REPLACEMENT OF FUEL PUMP FOR ROTAX® ENGINE TYPE 912 (SERIES) SB-912-053UL

FOR ROTAX® ENGINE TYPE 912 (SERIES) SB-912-053

Replacement of fuel pumps with part no. 892230, 892232, 892540 through part no. 892542 and Replacement of fuel pumps with part no. 892235, 892236, 892545 through part no. 892546 for ROTAX® engine type 912 (Series).

(see Fig.1)

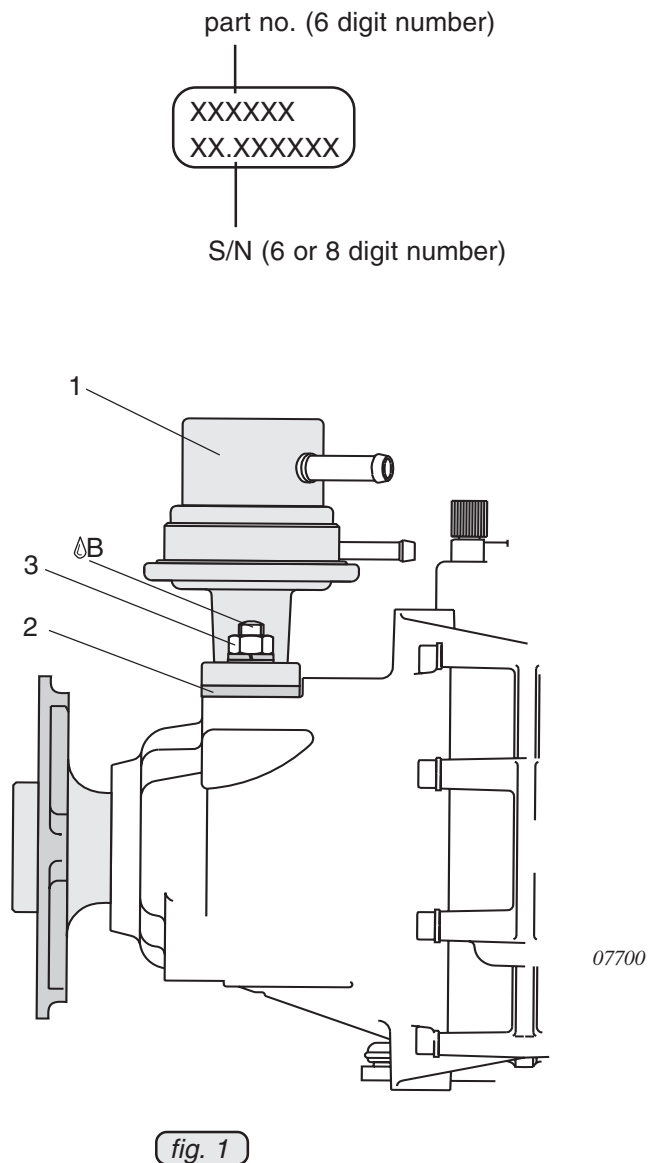
1. Remove fuel pump (1).
2. Gasket (2) replaced by new part.

■ **CAUTION:** Install new gasket supplied with new fuel pump. Do not reuse old gasket.

◆ **NOTE:** On the sealing surfaces of the gearbox housing and the fuel pump no sealing compound has to be used.

3. Install fuel pump.

4. Tighten uniformly hex. nuts (3) with LOCTITE 243. Tightening torque 15 Nm (133 in.lb).

◆ **NOTE:** The additional use of LOCTITE 243 should be applied at each removal/replacement of the fuel pump and/or gasket. A rework of already installed fuel pumps part no. 892542 and 892546 is not necessary.
